Tennessee Valley Authority, Post Office Box 2000, Soddy-Daisy, Tennessee 37384-2000

September 21, 2001

SEQUOYAH NUCLEAR PLANT (SQN) - UNITS 1 AND 2 - REVISION OF INSTRUMENTATION MEASUREMENT RANGE, BORON CONCENTRATION LIMITS, REACTOR CORE LIMITATIONS, AND SPENT FUEL POOL STORAGE REQUIREMENTS FOR TRITIUM PRODUCTION CORES (TPCs) - TECHNICAL SPECIFICATION (TS) CHANGE NO. 00-06

PROPOSED TECHNICAL SPECIFICATION (TS) CHANGE TS 00-06
AND TPBAR CONSOLIDATION ACTIVITY
DESCRIPTION AND EVALUATION OF THE PROPOSED CHANGE

FIG 5.6-1 Arrangements of Fuel Storage Regions in the Sequoyah Spent Fuel Storage Pool

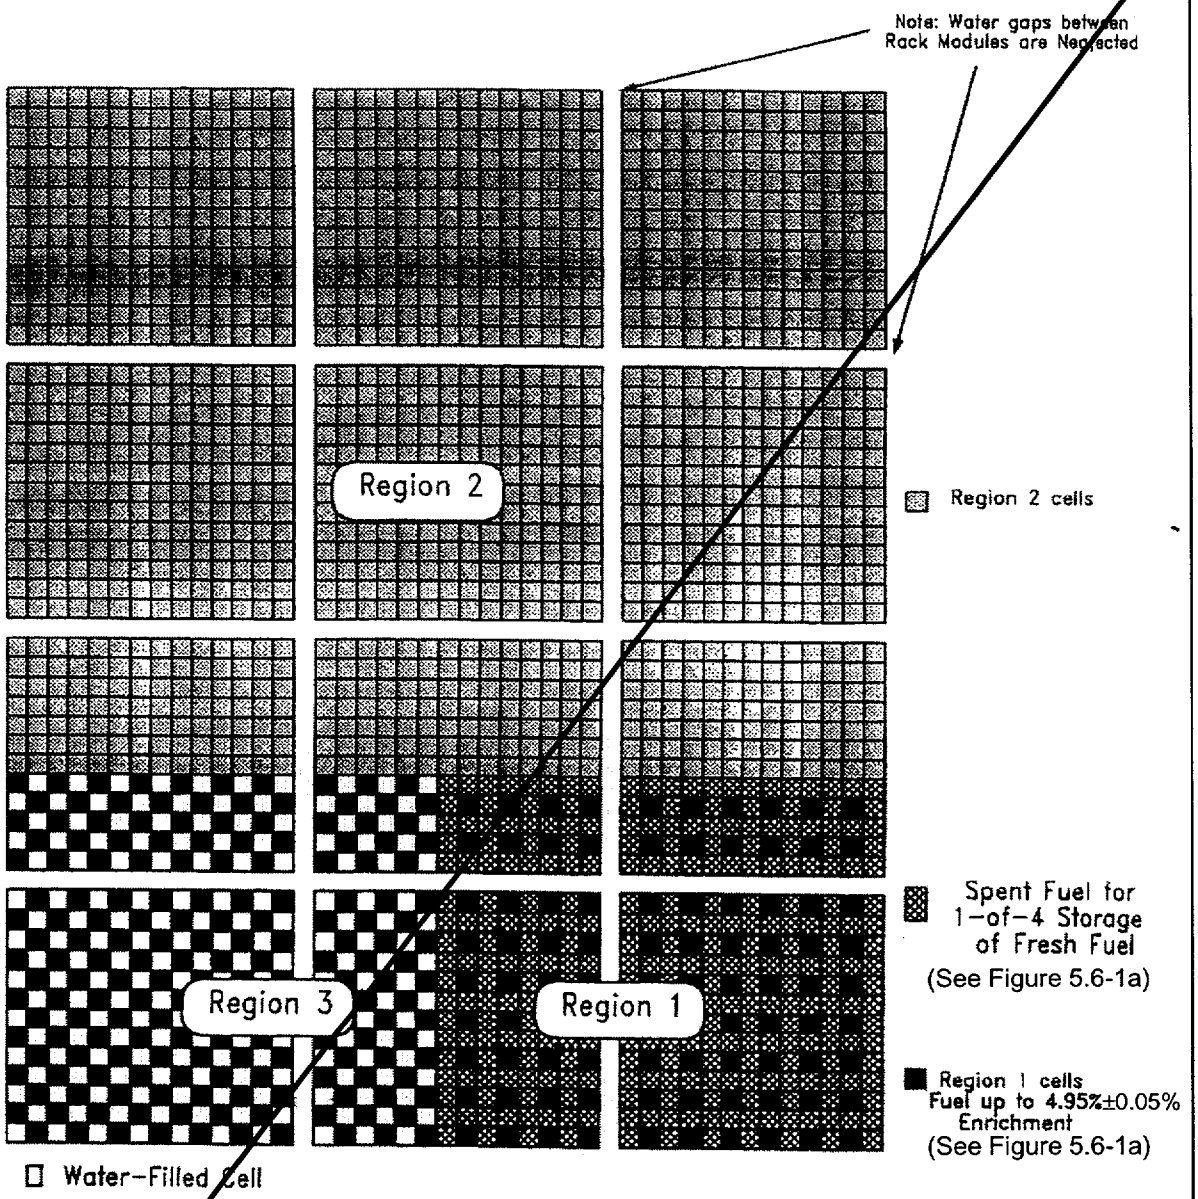
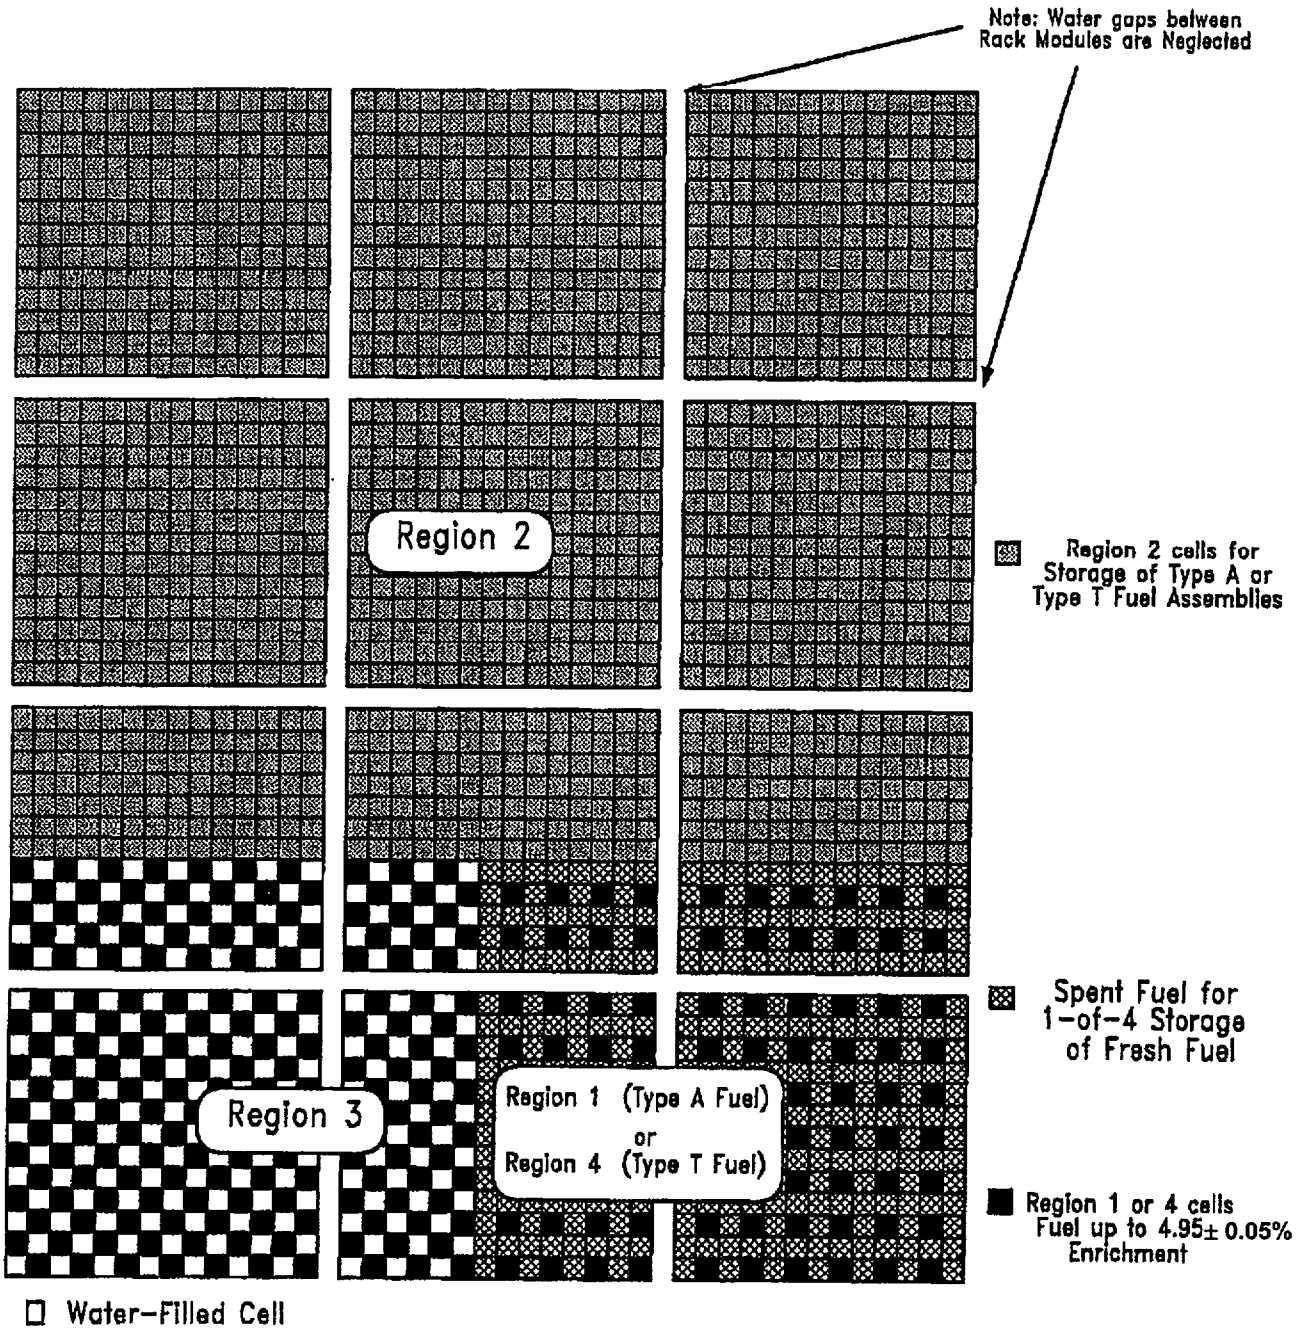
The figures and tables associated with Section 5.6.1.1 have been revised accordingly to properly represent the acceptable spent fuel storage patterns for each fuel type with appropriate enrichment, burnup, and cooling time requirements for storage in respective regions of the spent fuel pit. This change has revised the labels for the existing figures and tables to clarify their use for Type A spent fuel and has included other changes to reflect the new Type T spent fuel. New figures and tables for Type T spent fuel have been added with appropriate labels and information for controlling storage requirements for this fuel.

[Replace with Insert 12]

Insert 12

Fig. 5.6-1a Acceptable Storage Patterns for Checkerboard Storage of Fresh and Spent Fuel Assemblies in Region 1 or Region 4 – Example

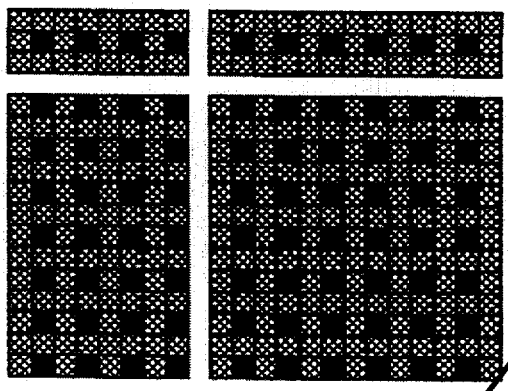
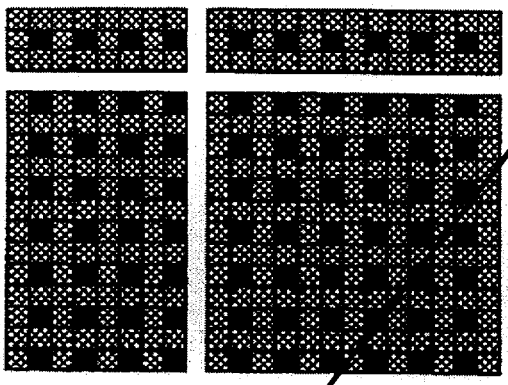
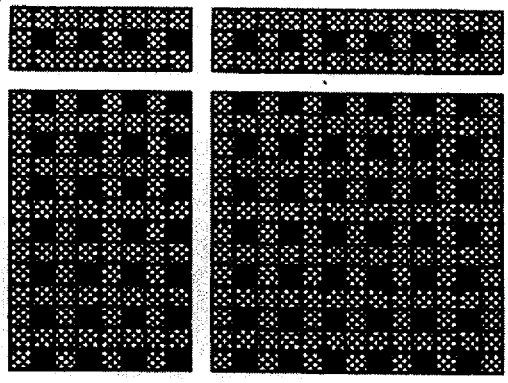
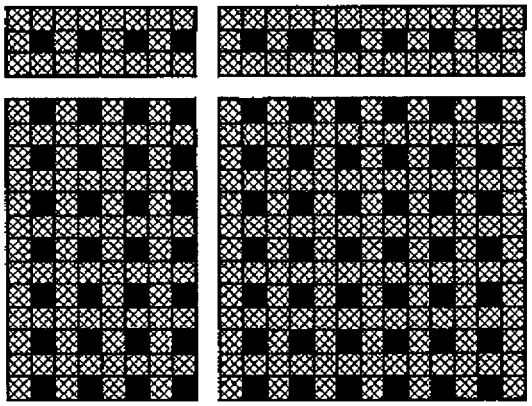
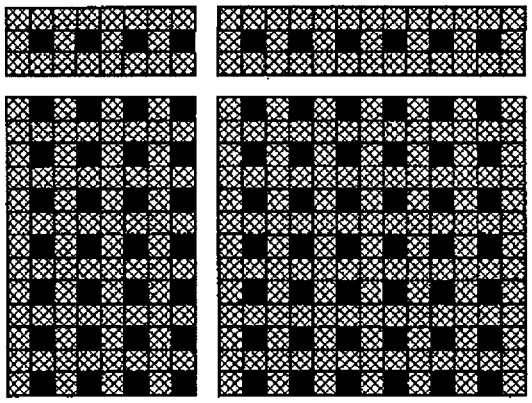
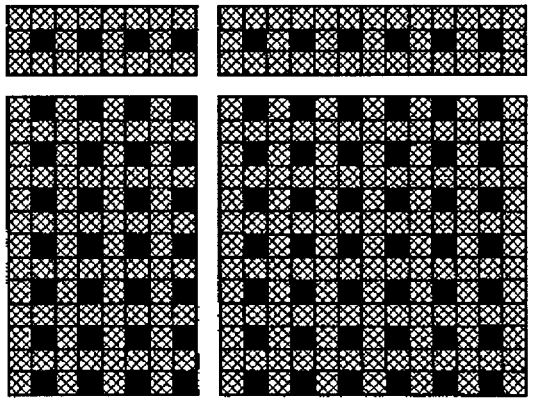
[Replace with Insert 13]

Insert 13

Fig. 5.6–4 Limiting Burnup Requirements in Region 2 for Face Adjacent Storage of Type T Spent Fuel Assemblies

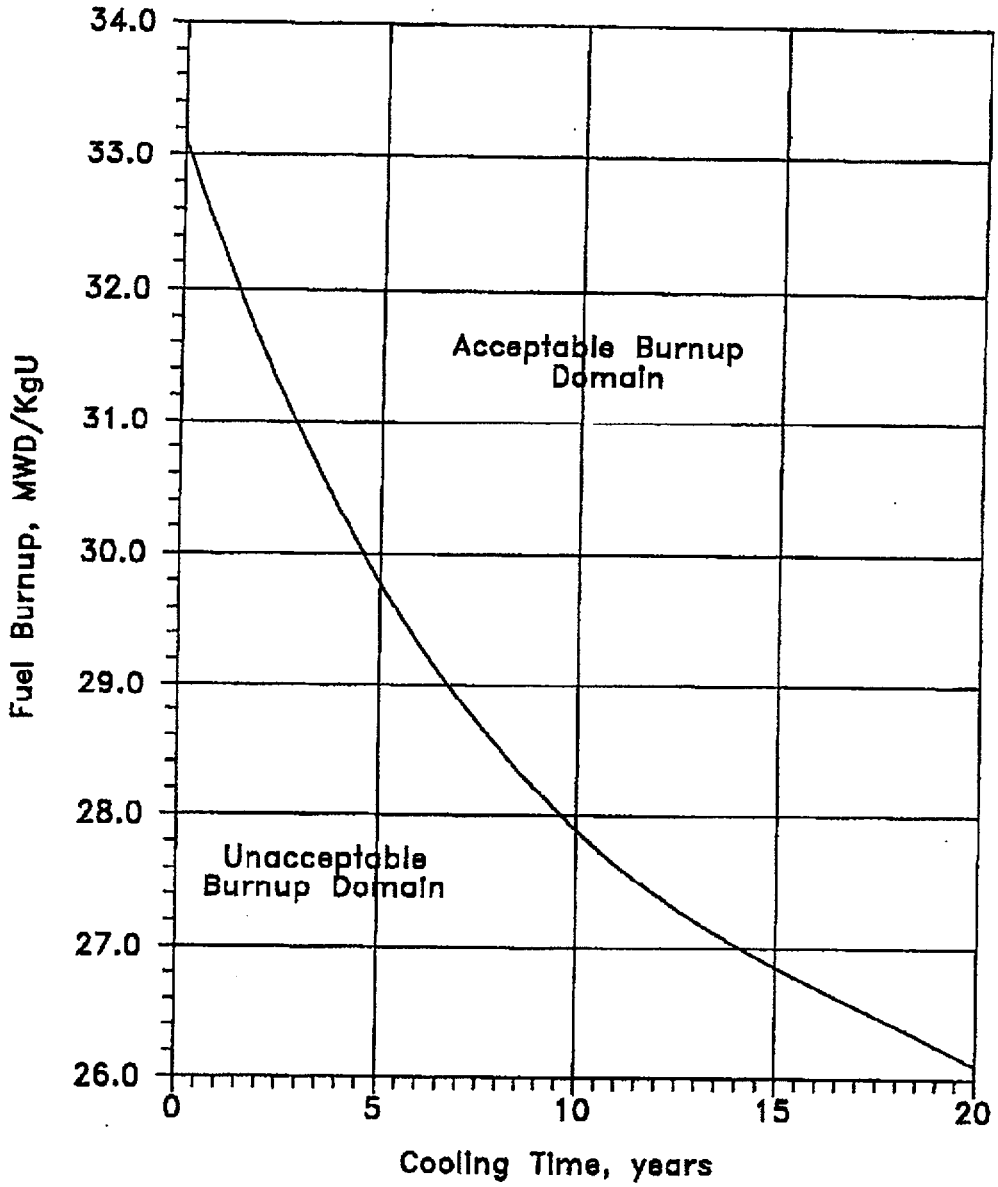
[Add Inserts 14, 15, and 16]

Insert 14

FIG 5.6-1 Arrangements of Fuel Storage Regions in the Sequoyah Spent Fuel Storage Pool

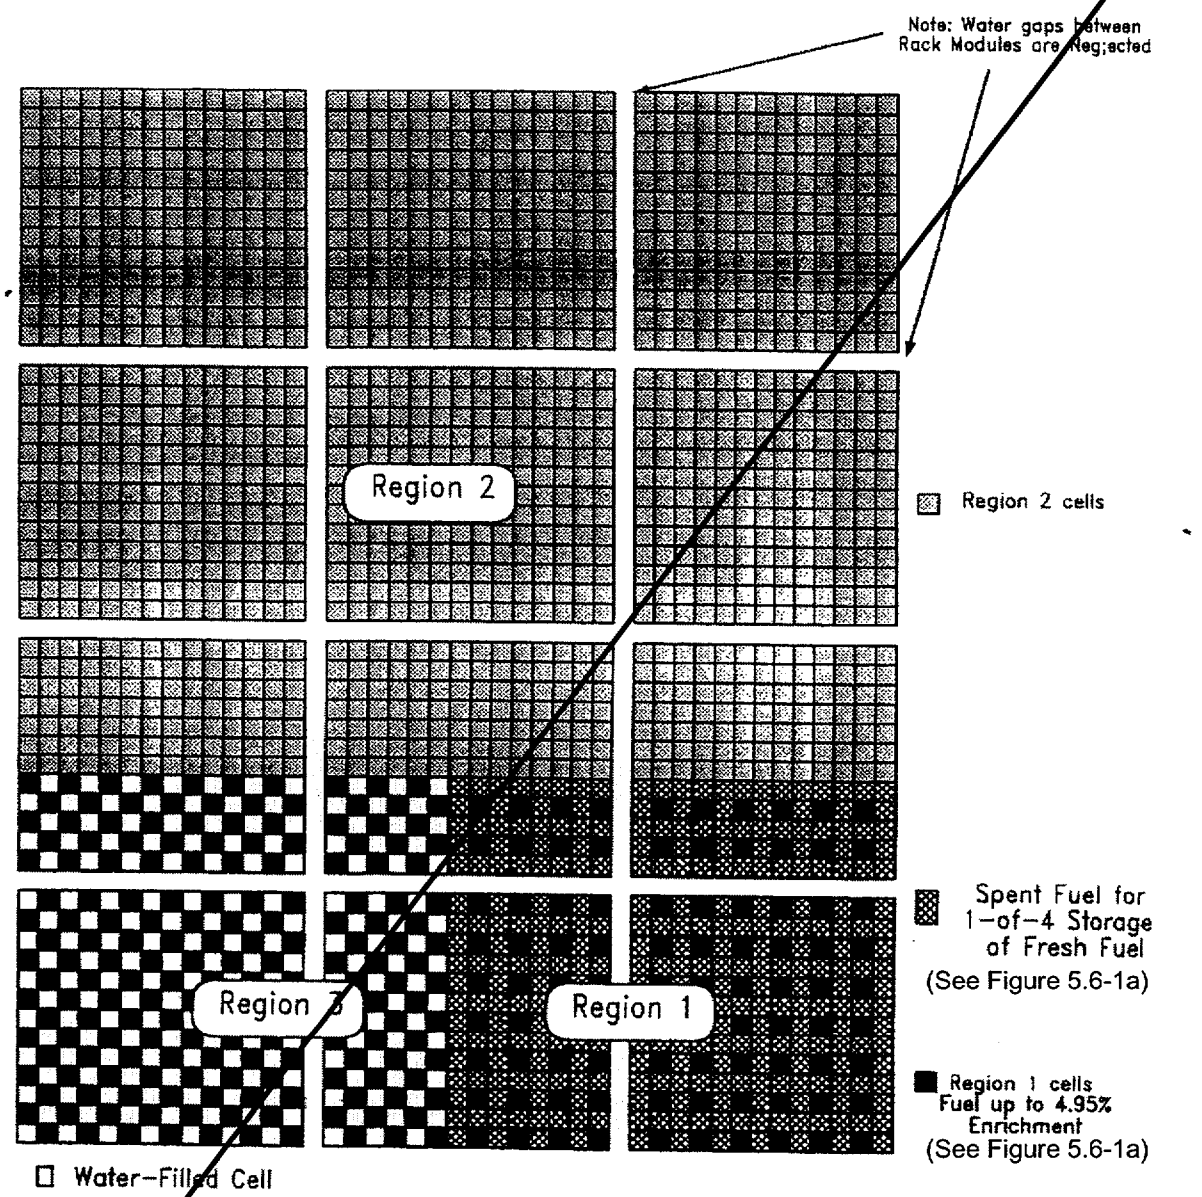
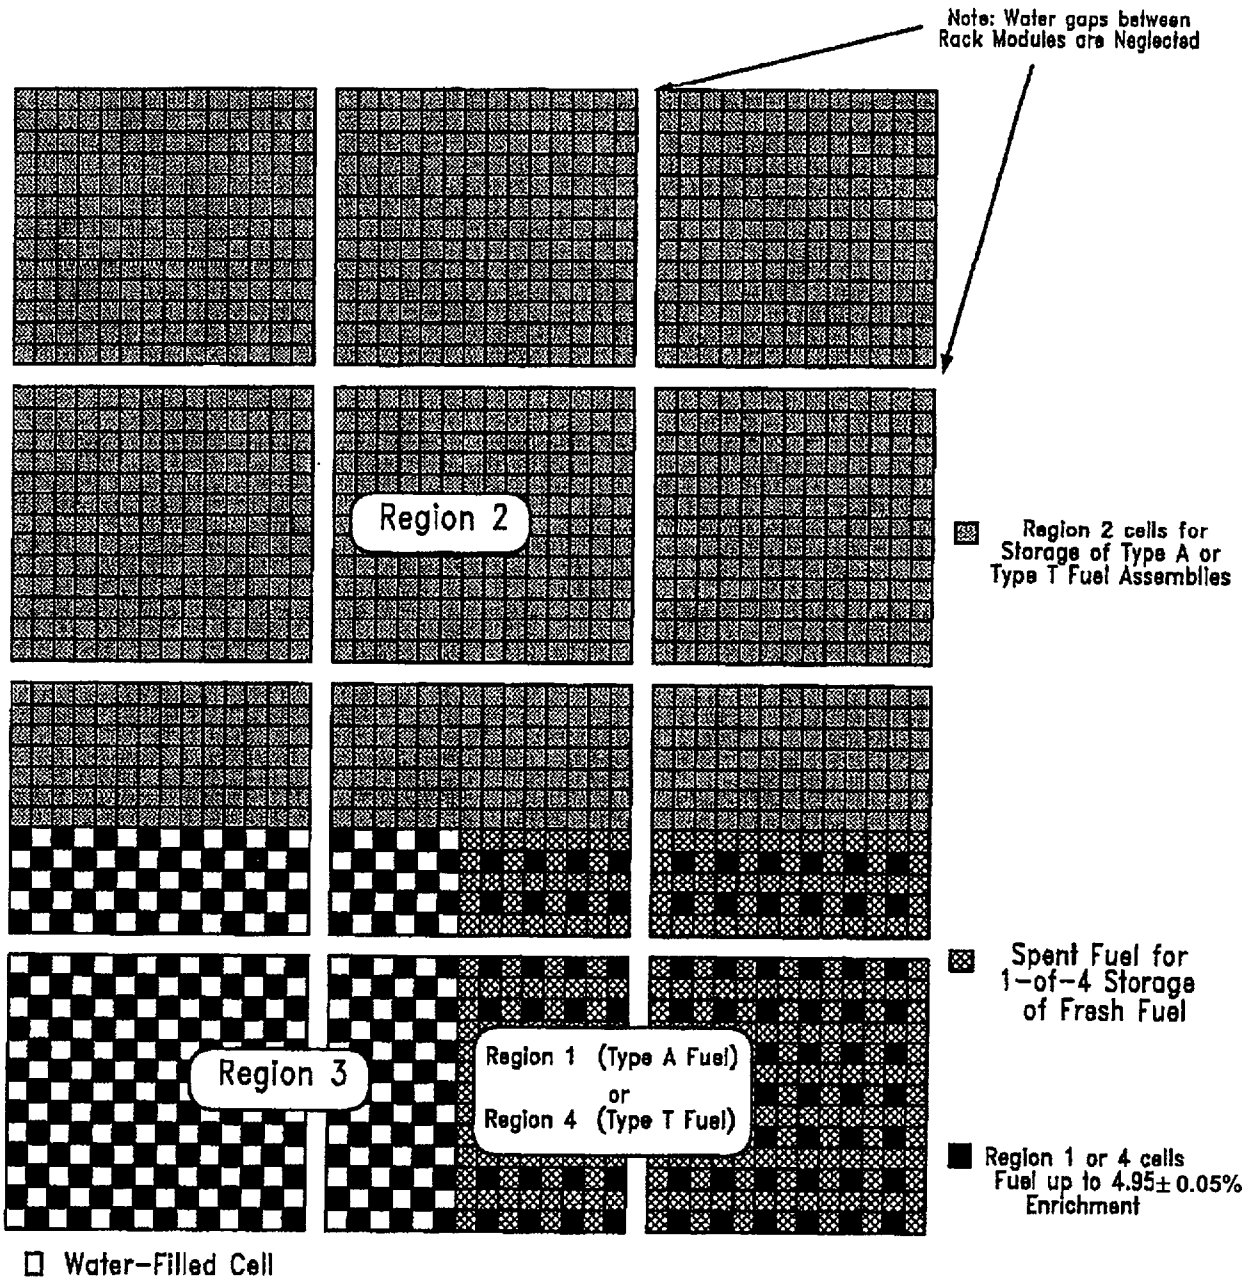
[Replace with Insert 12]

Insert 12

Fig. 5.6-1a Acceptable Storage Patterns for Checkerboard Storage of Fresh and Spent Fuel Assemblies in Region 1 or Region 4 – Example

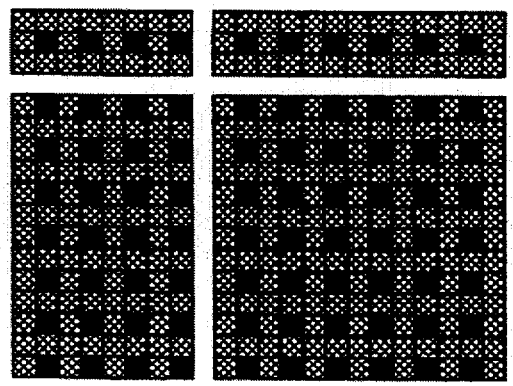
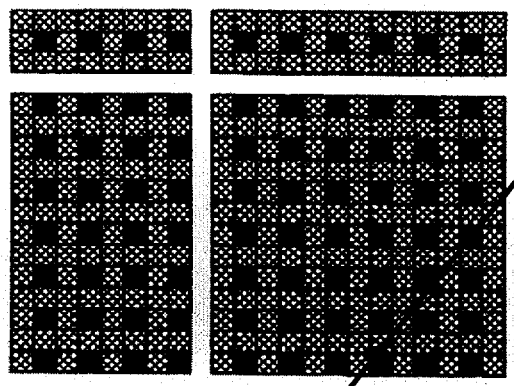
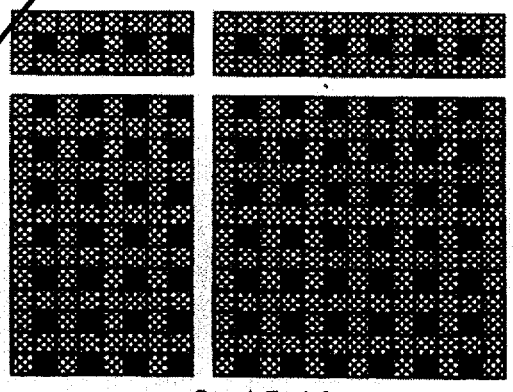
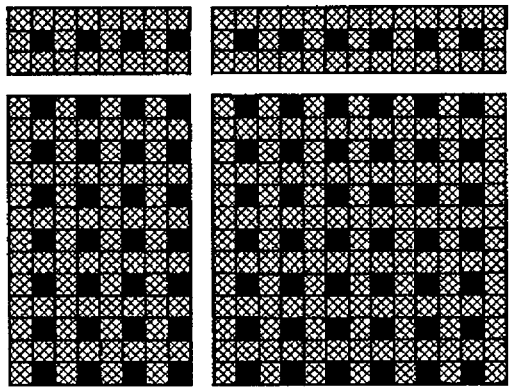
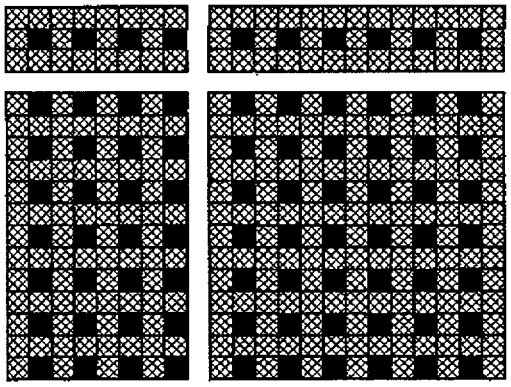
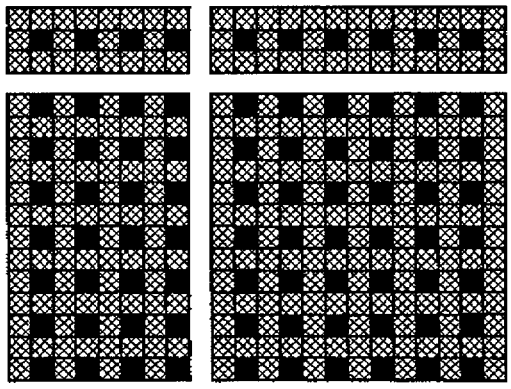
[Replace with Insert 13]

Insert 13

Fig. 5.6–4 Limiting Burnup Requirements in Region 2 for Face Adjacent Storage of Type T Spent Fuel Assemblies

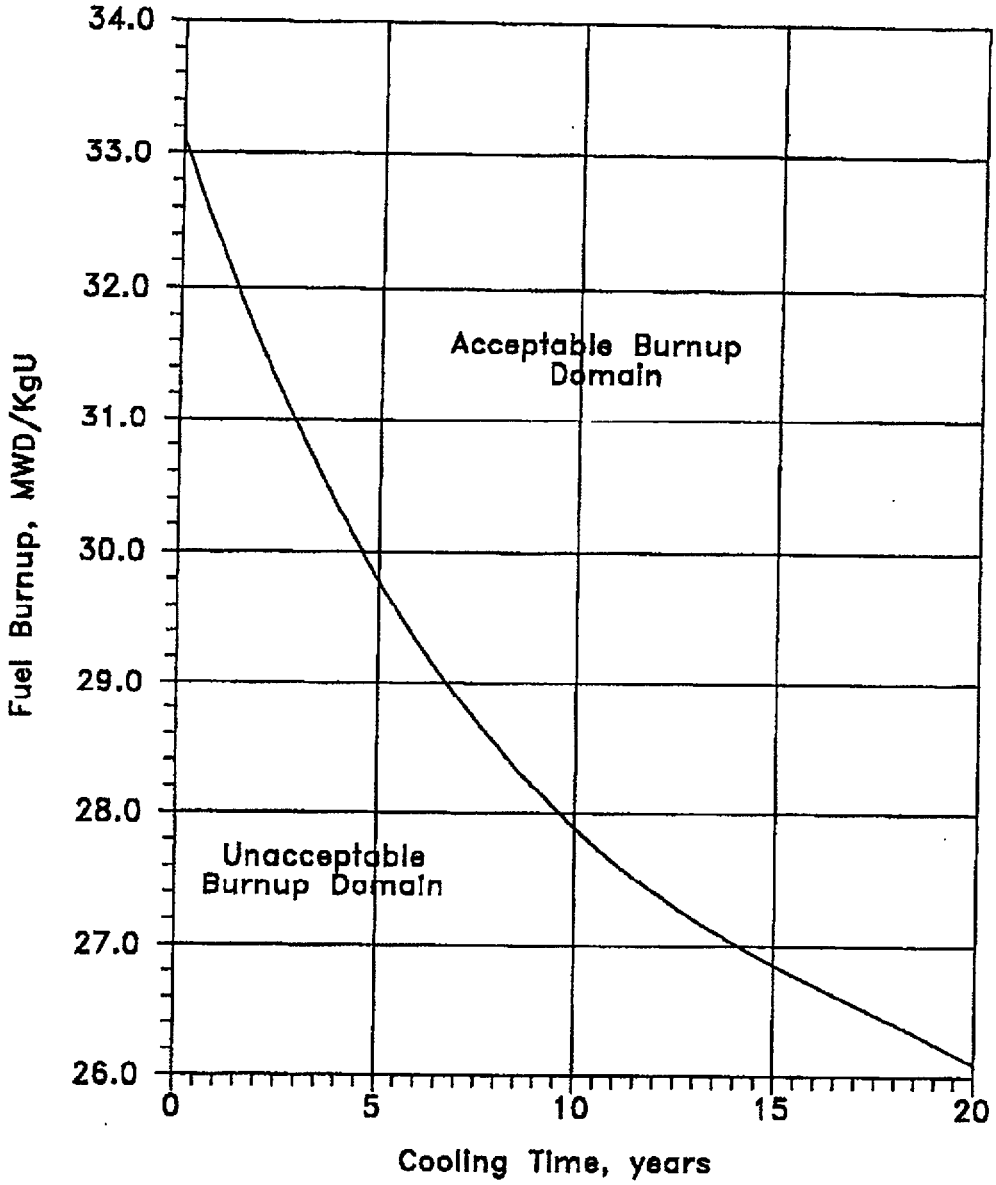
[Add Inserts 14, 15, and 16]

Insert 14
